Process Sheet

DESIG	PH	DRAWN BY	DART AEROSPACE PORT HADLOCK, W	
CHECK	ŒD 🚜	APPROVED	DRAWING NO.	REV. A
	#	4	DSI 9364	SHEET 1 OF 1
DATE			TITLE	SCALE
07.01.16			BUSHING INSTALLATION	NTS
Α		07.01.16	NEW ISSUE

DART SERVICE INSTRUCTION

TO AMEND IIN-D412-742 REV. B AND ICA-D412-742 REV. 1 REF. FAA STC: SR01583SE REF. CANADIAN STC: SH05-37 ISSUE 1

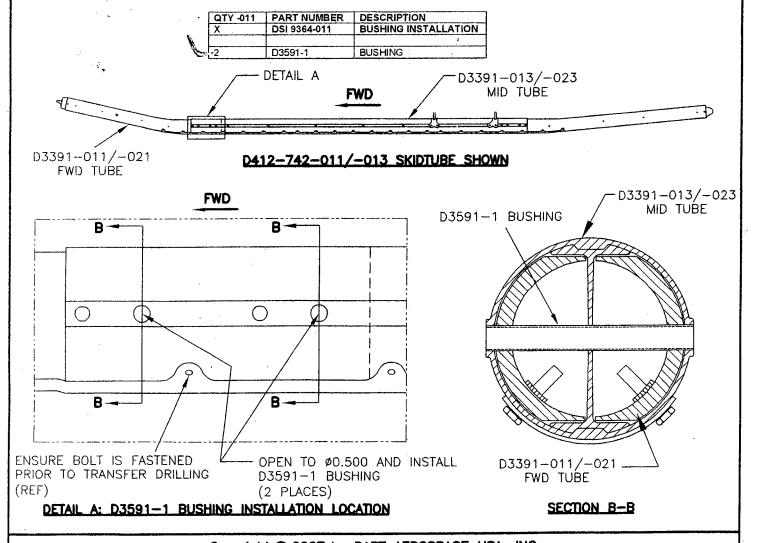
TO PREVENT THE D3391-011/-021 FWD TUBE FROM MOVING WITH RESPECT TO THE D3391-013/-023 MID TUBE, CUSTOMERS RECEIVING D412-742-011/-013 SKIDTUBES AT CHG 002 HAVE A D3591-1 BUSHING INSTALLED AT THE FWD SADDLE HOLES AS SHOWN IN DETAIL A (2 PLACES).

CUSTOMERS WITH D412-742-011/-013 SKIDTUBES AT CHG 001 CAN PROCURE THE DSI 9364-011 KIT AND INSTALL THE D3591-1 BUSHINGS AS FOLLOWS:

- 1) REMOVE SKIDTUBE/SADDLES FROM AIRCRAFT USING SECTION 32.7 OF ICA-D412-742 AS A GUIDELINE.
- 2) TRANSFER DRILL 1/2" HOLES (Ø0.500) INTO THE FWD SADDLE HOLES AT THE LOCATIONS SHOWN (2 PLACES) THRU THE D3391-013/-023 MID TUBE AND D3391-011/-021 FWD TUBE. DO NOT OPEN UP HOLES IN D2571/D2572 FWD SADDLES.
- 3) REMOVE FWD TUBE FROM MID TUBE, DEBURR DRILLED HOLES, TOUCH UP HOLES WITH MIL-P-85582 OR MIL-P-23377 PRIMER
- 4) RE-INSTALL D3391-011/-021 FWD TUBE INTO D3391-013/-023 MID TUBE USING SECTION 32.7 OF ICA-D412-742 AS A GUIDELINE EXCEPT INSTALL D3591-1 BUSHINGS AS SHOWN IN DETAIL A USING LPS LABORATORIES LPS-3 CORROSION INHIBITOR PRIOR TO INSTALLING THE D2571/D2572 SADDLES.
